Prairie Island Independent Spent Fuel Storage Installation
Docket No. 72-10
Materials License No. SNM-2506

Supplement to License Renewal Application – Response to Second Request for
Additional Information (TAC No. L24592)

SUPPLEMENT TO LICENSE RENEWAL APPLICATION
RESPONSE TO REQUEST FOR ADDITIONAL INFORMATION

Figure A2.10-1
Two Meter Gamma Dose Rates

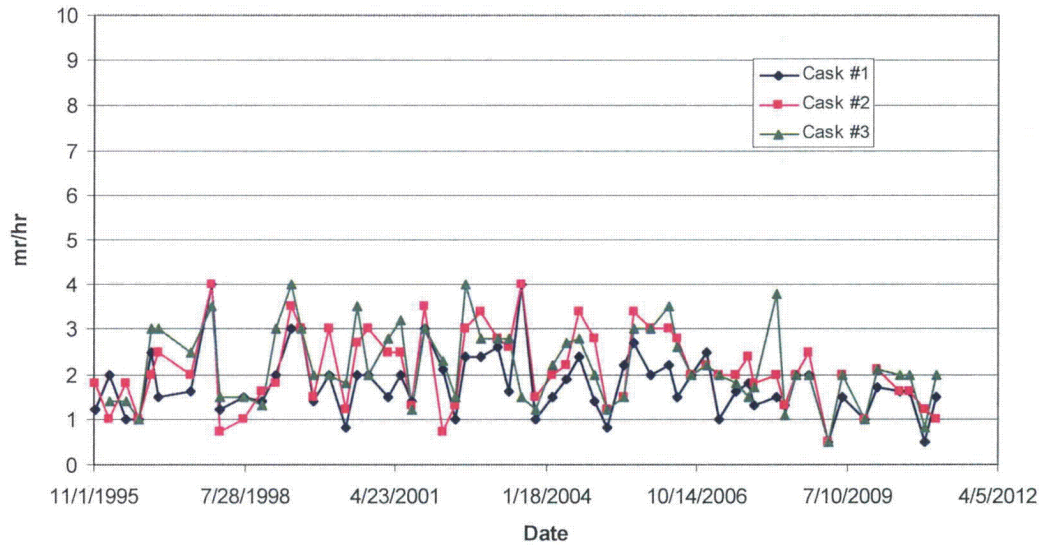
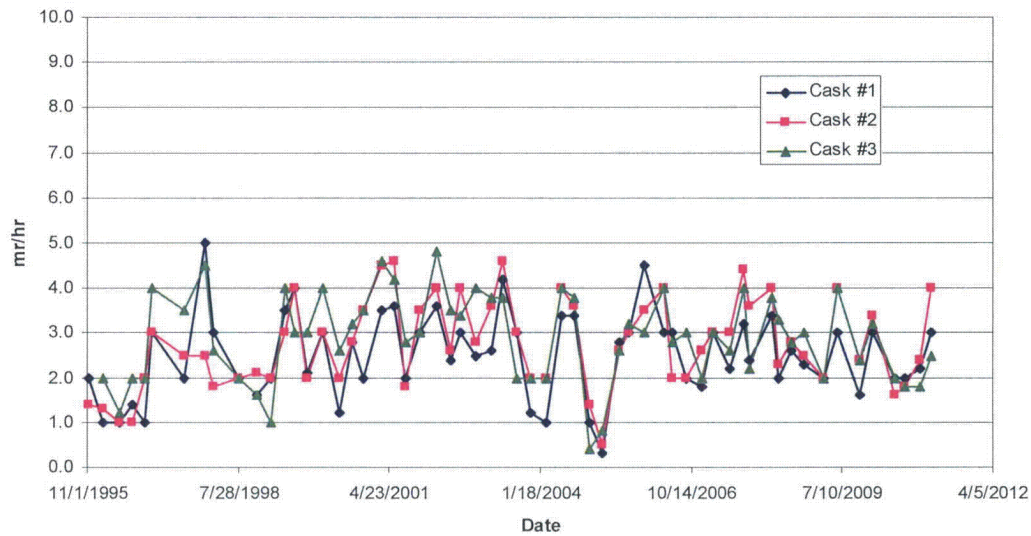
The staff believes that due to either inconsistencies in the measurement technique, equipment, locations, variations in background, or a combination of all of these factors, the data (LRA Figure A.2.10 -1.2, and RAI A-1 response) presented is insufficient to detect degradation of the

NSPM performs periodic radiation surveys of the in-service casks. Trending of these surveys results shows no evidence that the shielding is degrading. Figure A2.10-1 provides the gamma dose rates at two meters from the three casks that have been in-service the longest. Figure A2.10-2 provides the neutron dose rates at two meters from the three casks that have been in-service the longest.
